**Wichita-Sedgwick County
Metropolitan Area
Planning Department**

February 5, 2025

RE: CUP2025-00002 – Administrative Adjustment in the City to the Trinity Academy CUP DP-352, to reduce the building setback along North Garnett Street to 20 feet on property zoned LC Limited Commercial District; generally located on the north side of East 21st Street North, within one-quarter mile west of North 127th Street East.

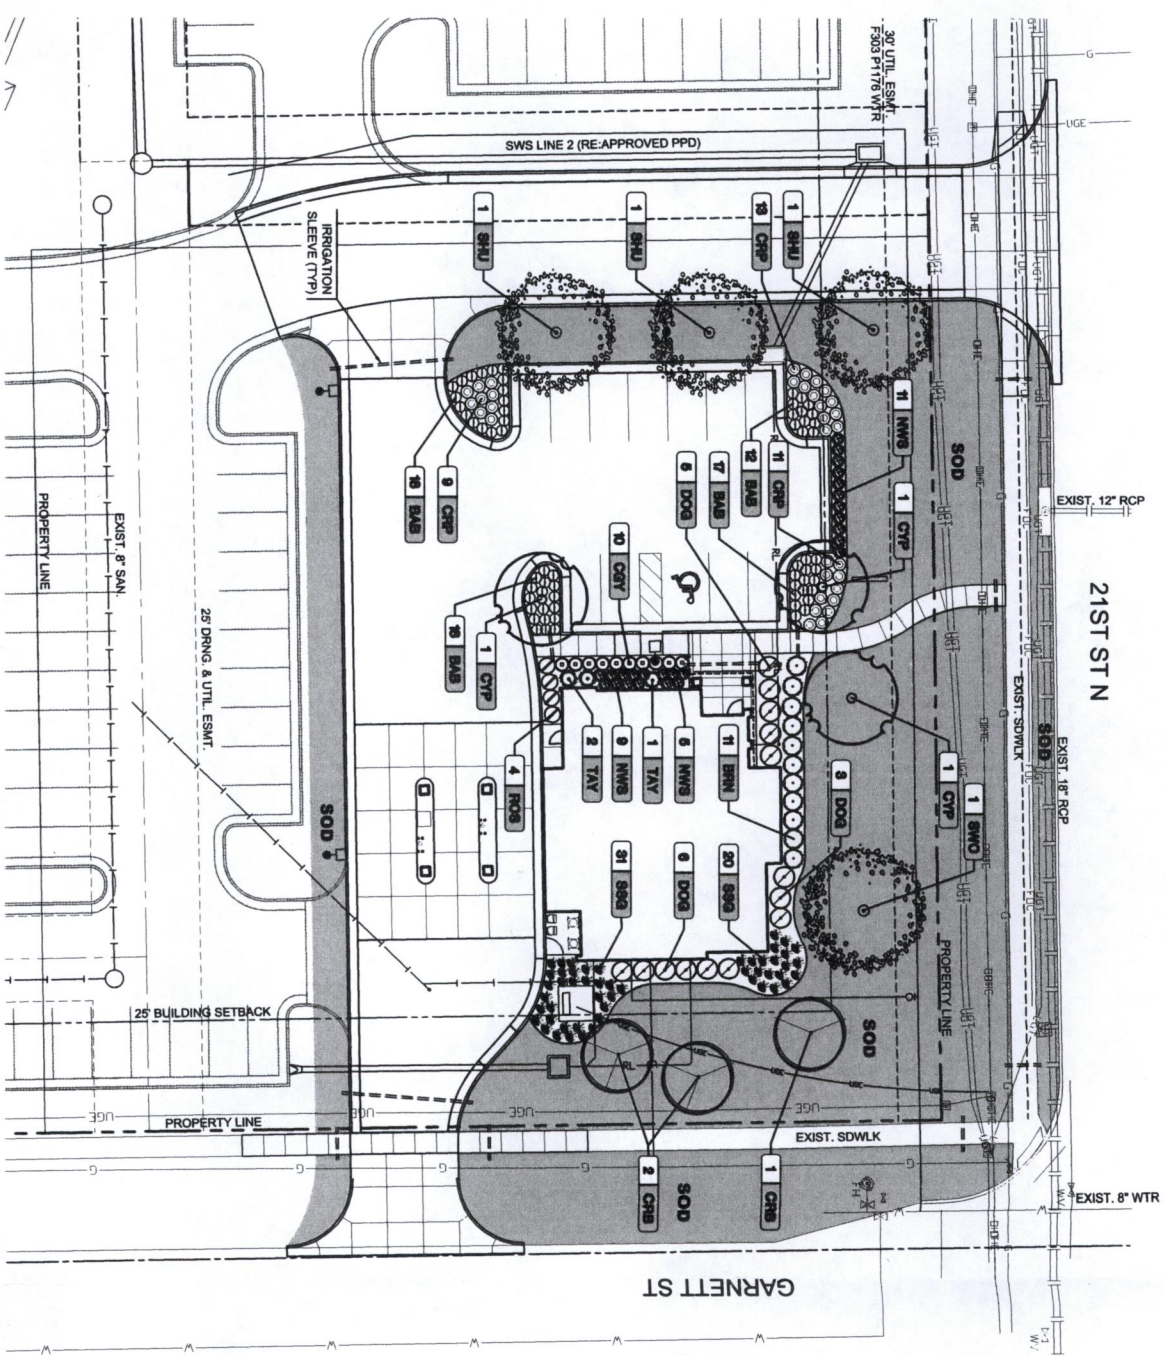
The following reflects staff's approved text modifications identified in red letters.

8. Building Setbacks are as shown hereon; 25-foot along 21st Street ~~frontage and Garnett Street frontages~~ and 20 feet along Garnett Street frontage, if not shown they shall be as specified in the

Wichita-Sedgwick County Unified Zoning Code for the corresponding base zoning district property development standards or as specified below. If contiguous Parcels are developed under the same ownership, setbacks between Parcels will not be required. If not contiguously owned the minimum side/rear setback shall be 10 feet.
